**PLANNING & ZONING BOARD
AGENDA ITEM 6A**

The applicant, Lyngblomsten at Lino Lakes, LLC, submitted a Land Use Application for PUD Amendment #4. They are requesting an amendment to the PUD Preliminary Plan/Preliminary Plat (“PUD Amendment”) to construct a 4-story mixed use building at the southeast corner of the site. The first floor would be commercial uses, and the other three floors would be 59 market-rate independent living units for residents age 55 and older.

Proposed PUD Preliminary Plan Amendment #4

Re: Lyngblomsten Nursing Home – Mixed (Residential/Commercial) Use Addition
Revised Preliminary PUD Plan Review
027097-000

SITE PLAN SOUTH

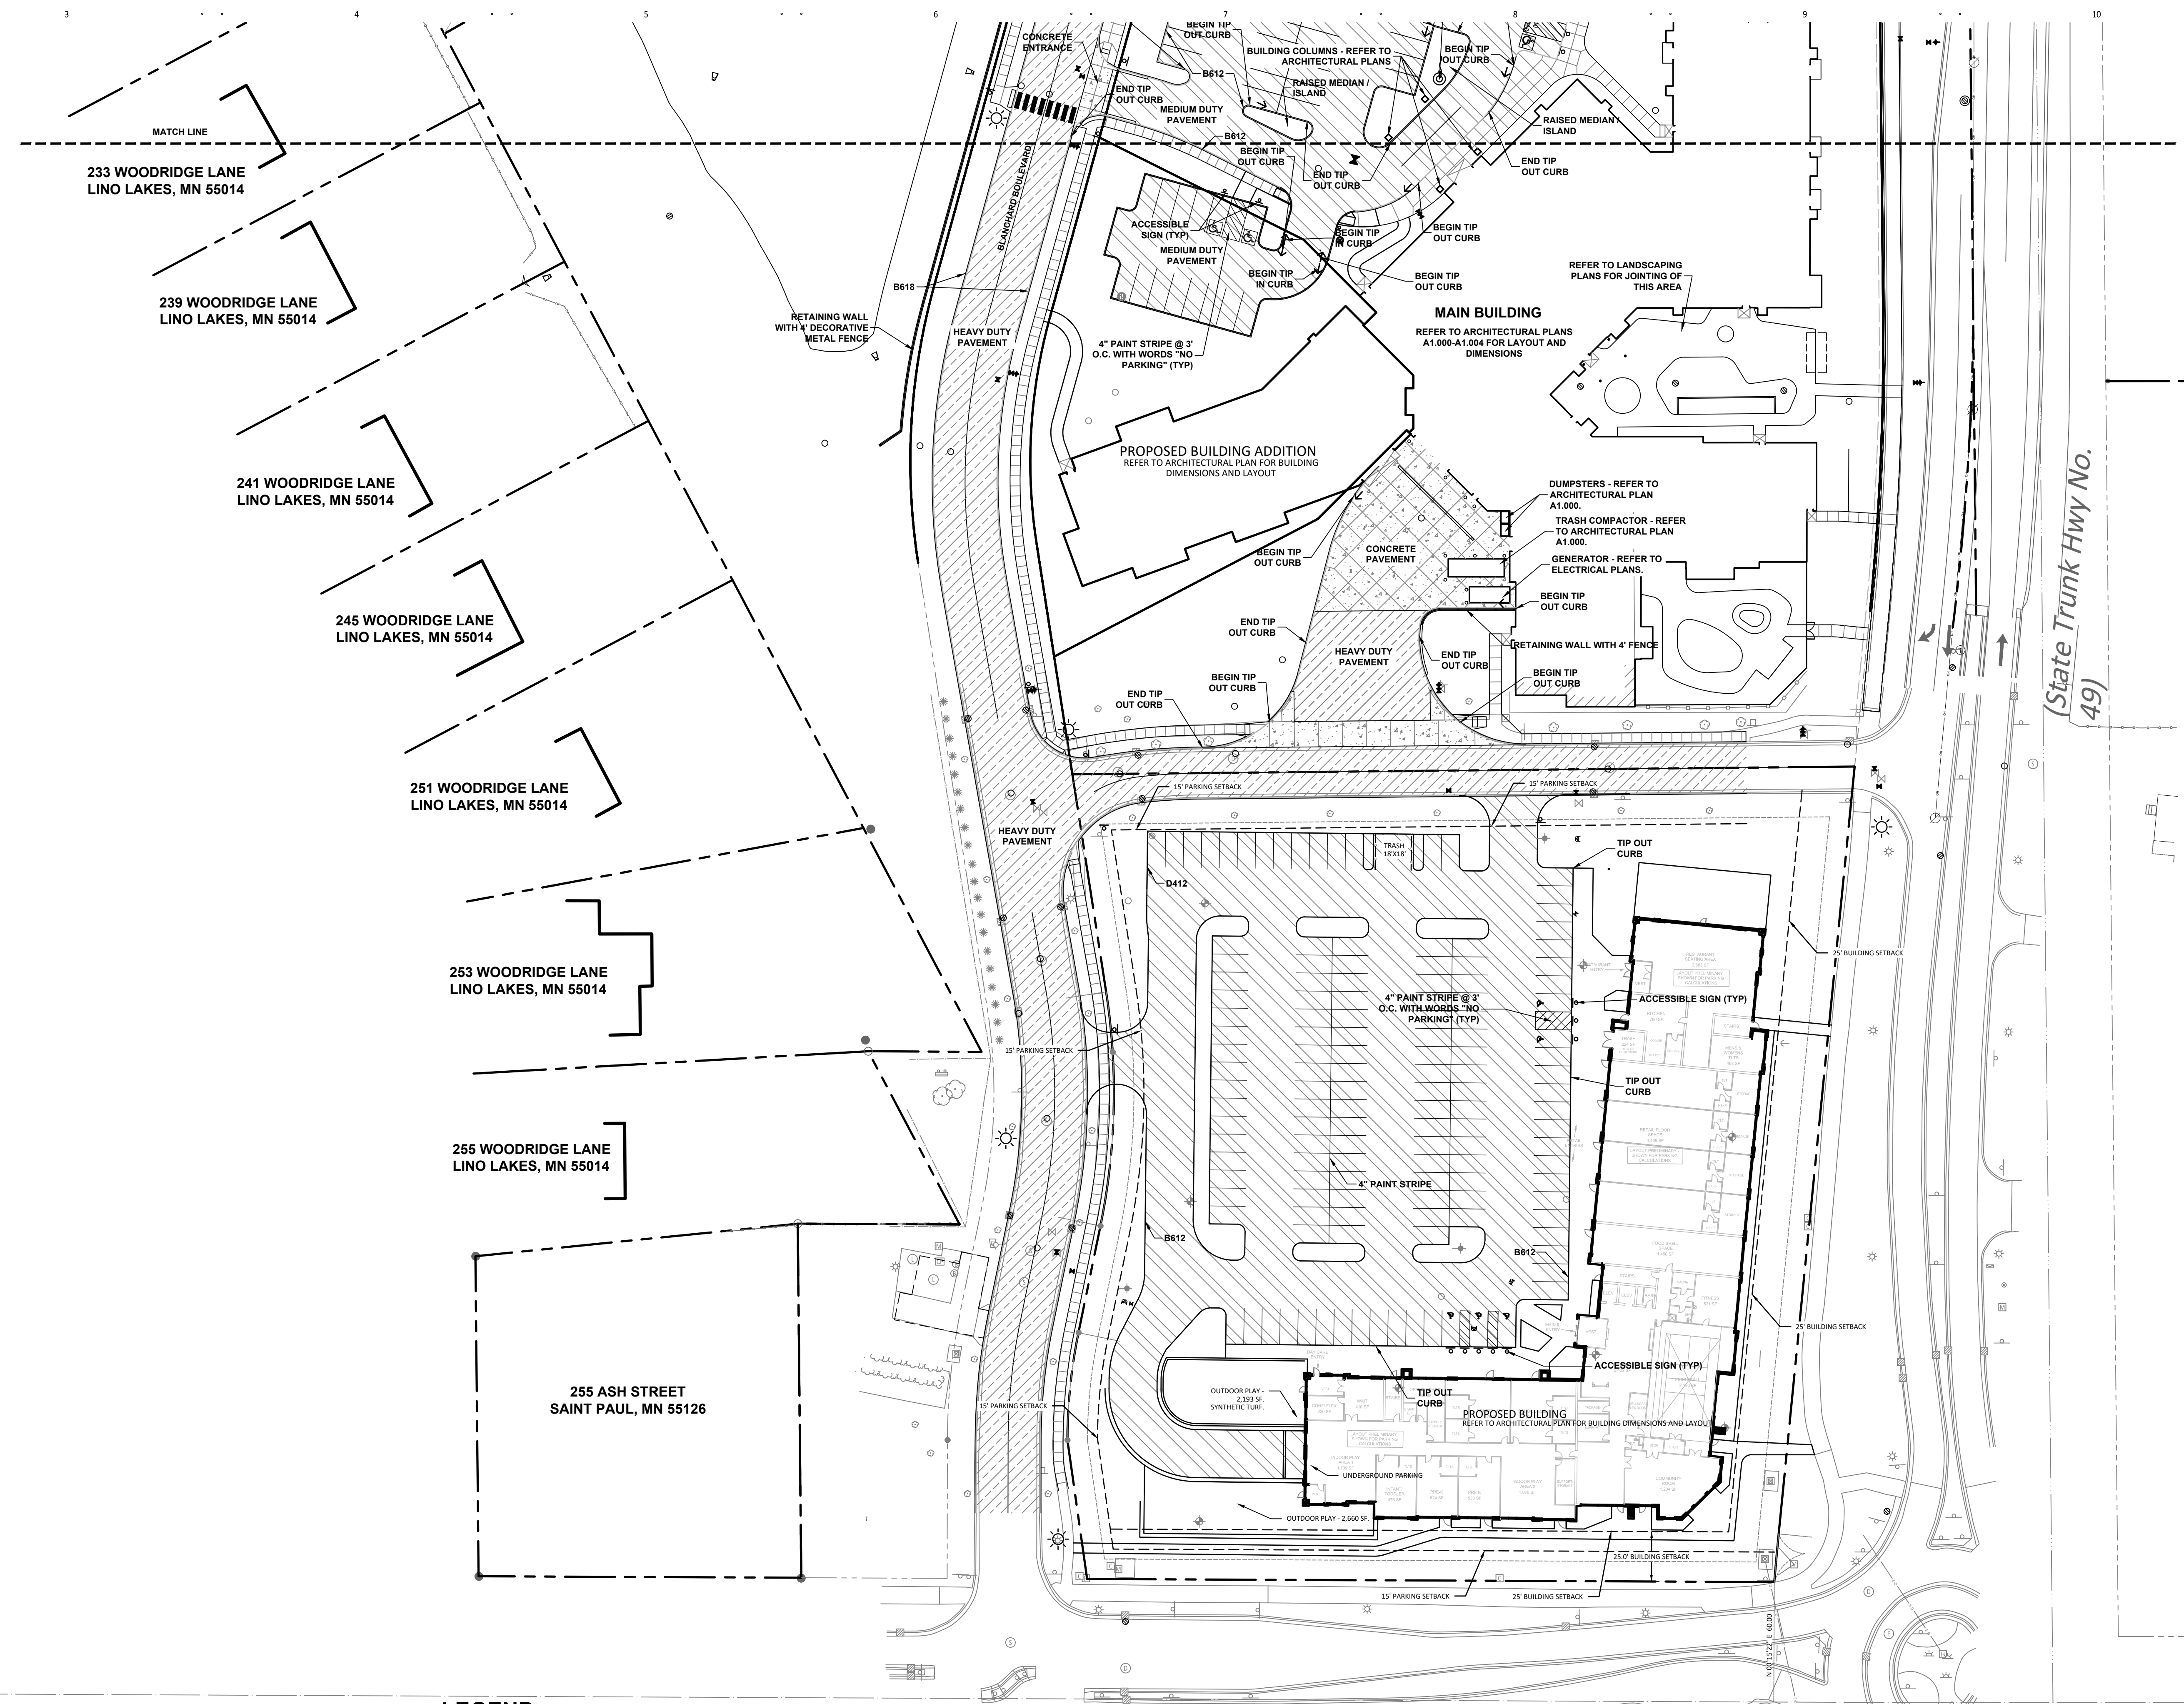
5. Sheet C1.22, Site Plan South:
 - a. Exterior trash enclosures are not allowed. Plans shall be revised accordingly.
 - b. Parking space totals per row shall be added.

- c. A sidewalk south of Lyngblomsten Drive from the Hodgson Rd trail shall be added to connect with the proposed sidewalk in front of the restaurant.

- e. The parking calculations table shall match that as shown on page 9 of this staff report.
 - i. Calculations shall also include proper rounding.
6. Sheet C1.23, Striping and Signage Plan Overall:

F3 MIXED-USE BASEMENT LEVEL OVERALL FLOOR PLAN
1/16" = 1'-0"

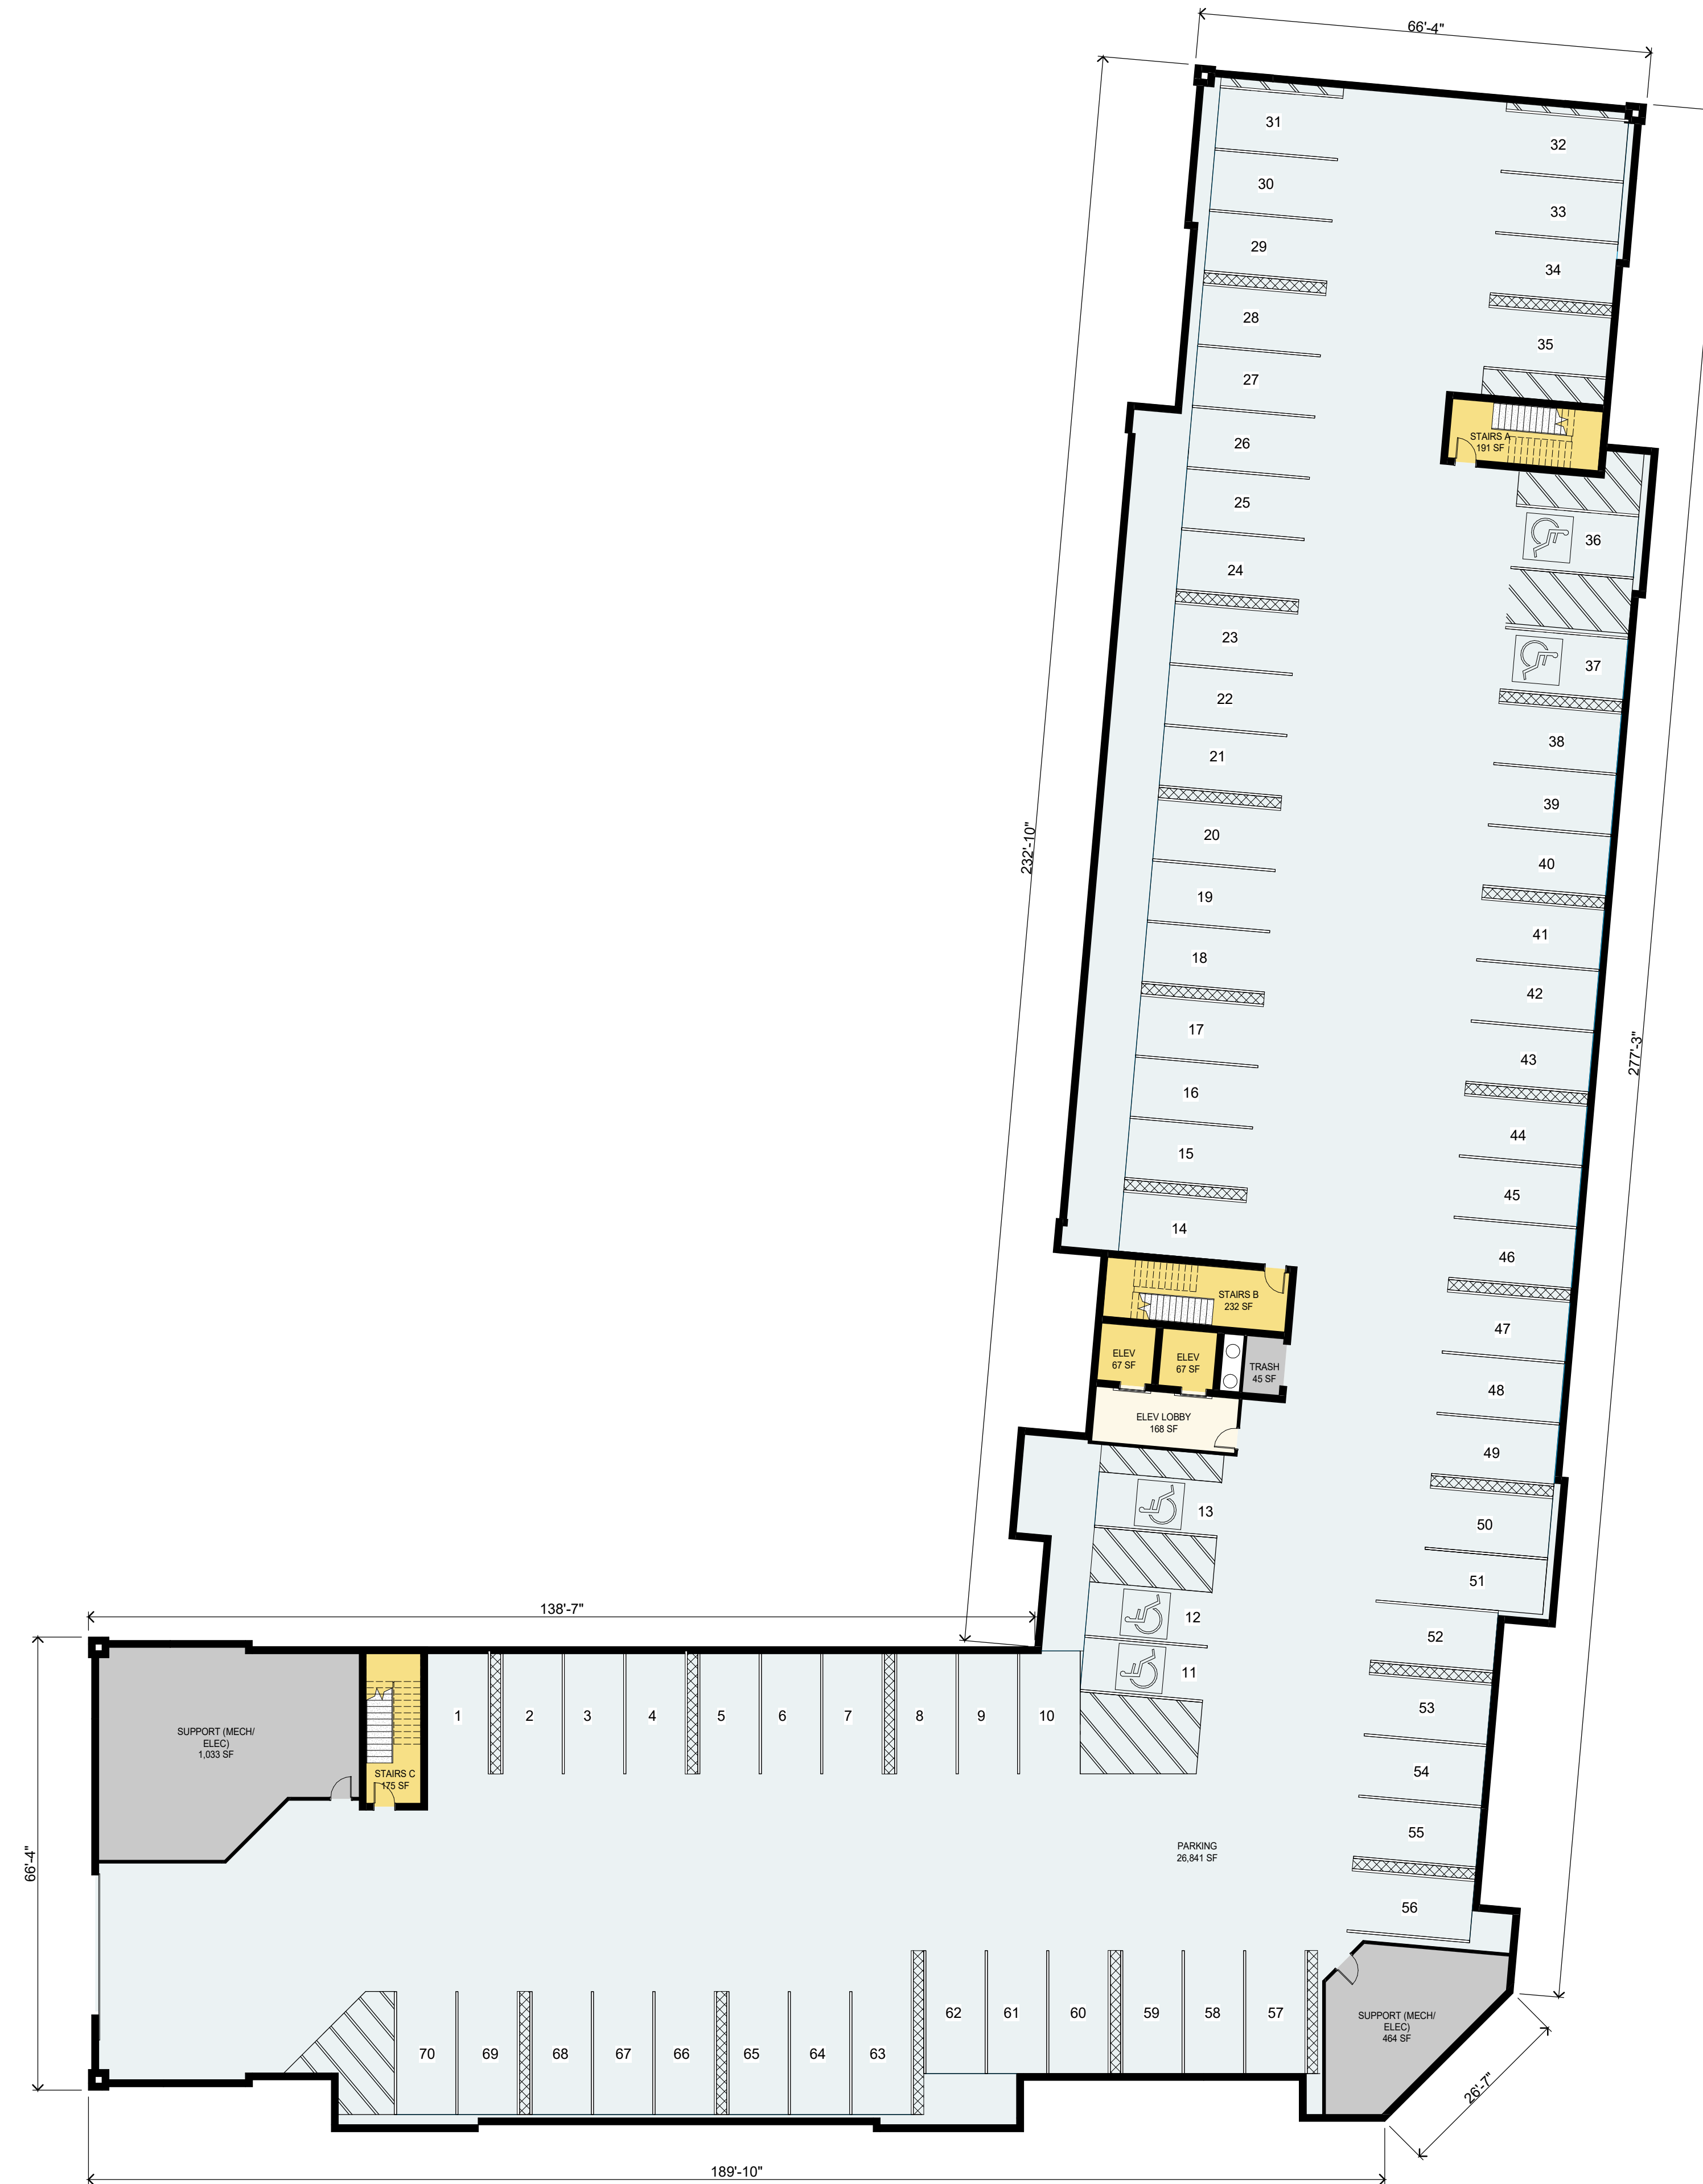
- a. Twenty-four (24) ft wide drive aisles shall be maintained.
 - i. North end near staircase is only 20ft wide and shall be revised.
 - ii. Re-evaluate ADA parking spaces on the north end near the stairs and not near elevators.
